**RESOLUTION SETTING HEARING ON REQUEST FROM
THE VILLAGE AT GRAY'S LAKE LLC TO REZONE AND APPROVE PUD CONCEPTUAL
PLAN FOR PROPERTY LOCATED 2500 AND 2710 FLEUR DRIVE**

Communication from the City Plan and Zoning Commission advising that at their September 5, 2019 meeting, the following action was taken regarding a request from The Village at Gray's Lake, LLC (owner) represented by Jason Grove (officer) to rezone the property located at 2500 and 2710 Fleur Drive from "M-3" Limited Industrial District and "R-3" Multiple-Family Residential District to "PUD" Planned Unit Development.

CONCEPTUAL PLAN THE VILLAGE AT GRAY'S LAKE

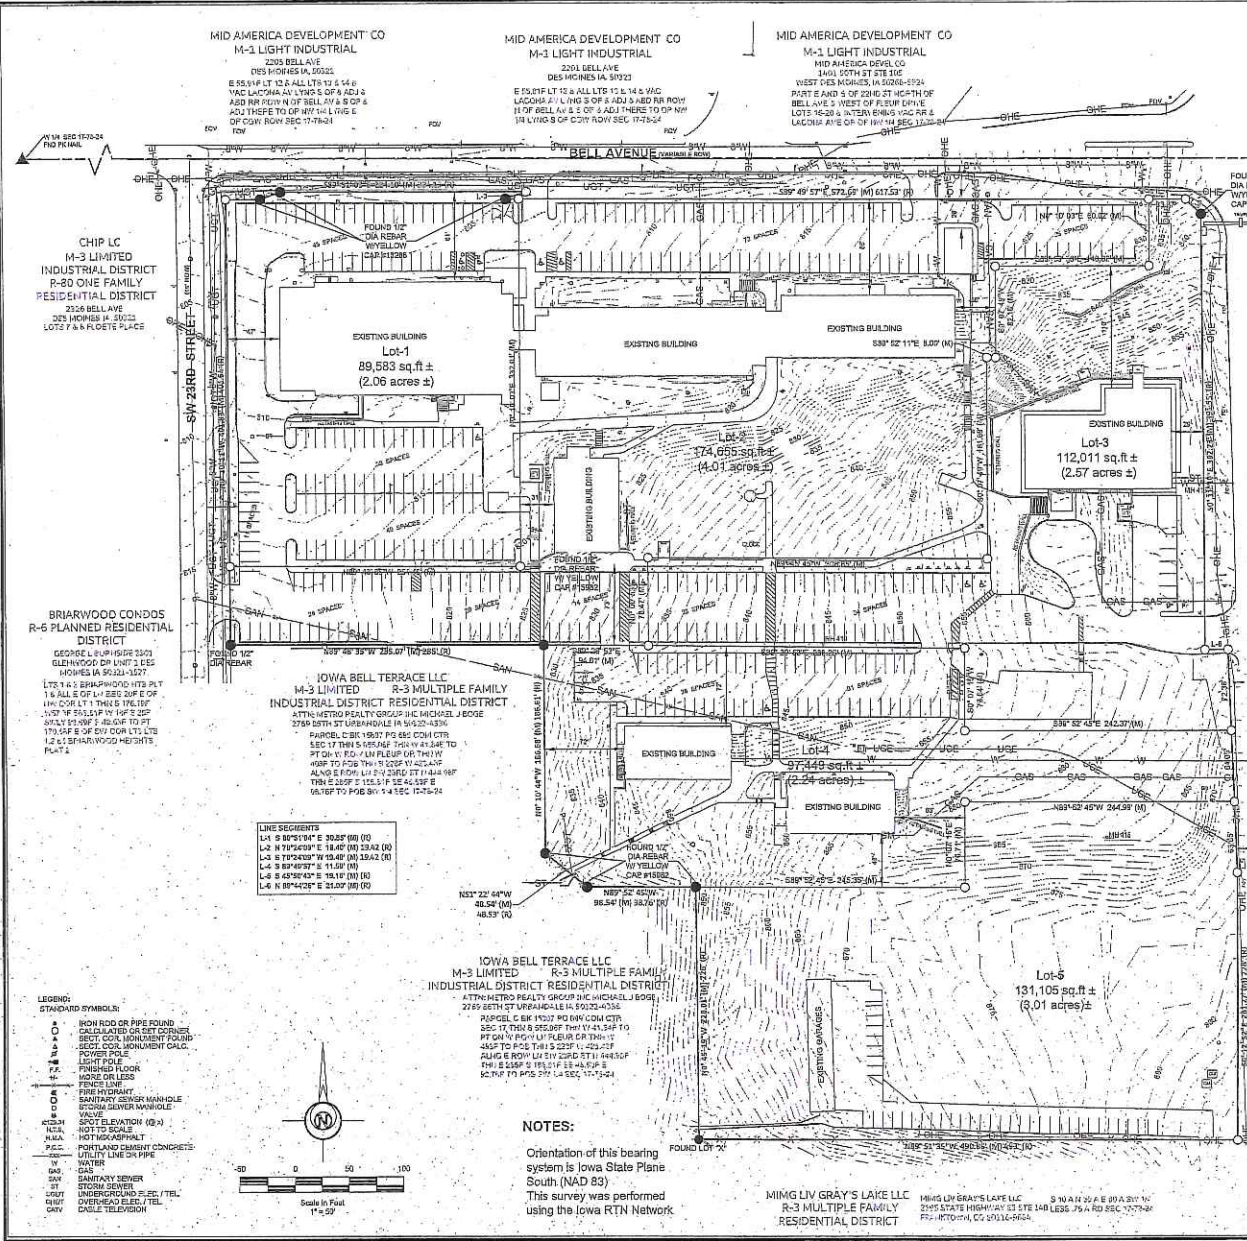
3. **Stormwater/Drainage:** Engineering staff has requested that the PUD Conceptual Plan be revised to include a statement as to how stormwater management would be handled with future redevelopment.

5. **Site Review:** With any reuse of buildings that would trigger a development review by the Permit and Development Center, there are a number of comments that should be added into the PUD Conceptual Plan as design guidelines for administrative review of those documents.

- A) **Streetscape:** Street Trees should be spaced 30' apart within the right-of-way along each frontage. Trees should be no closer than 15' to a street light.
- B) **Interior Lot Landscaping:** For rows of parking with more than 8 stalls, a landscape island is required for every 9th parking space with the result of no more than 8 continuous parking spaces in a row without a landscape island.
- C) **Frontage Perimeter Landscaping:** The required area shall be a minimum of 12-feet in depth measured from the street property line with a 3-foot berm or landscaped screen. Shade trees and shrubs shall be provided at a minimum of 1 tree and three shrubs per 40 lineal feet on center.

- D) Pedestrian access from any building to a street sidewalk shall be provided and clearly marked / striped on site. Lighting along pedestrian walks shall be a maximum of 15' in height.

- E) No new mechanical equipment, meters, transformers, condensers, or other such equipment shall be provided on any street side façade. At minimum, such equipment shall be setback from the street façade a minimum of 15'.

- F) Any mechanical equipment interior to the site shall be softened with landscaping material outside any equipment clearance setbacks.
- G) Mechanical vents shall not protrude from any street facing façade.

- H) A minimum 5' sidewalk is required along each frontage.
- I) All new utilities services shall be placed underground.
- J) All parking lot lighting shall be no taller than 20' from grade and shall be cut-off type fixtures.
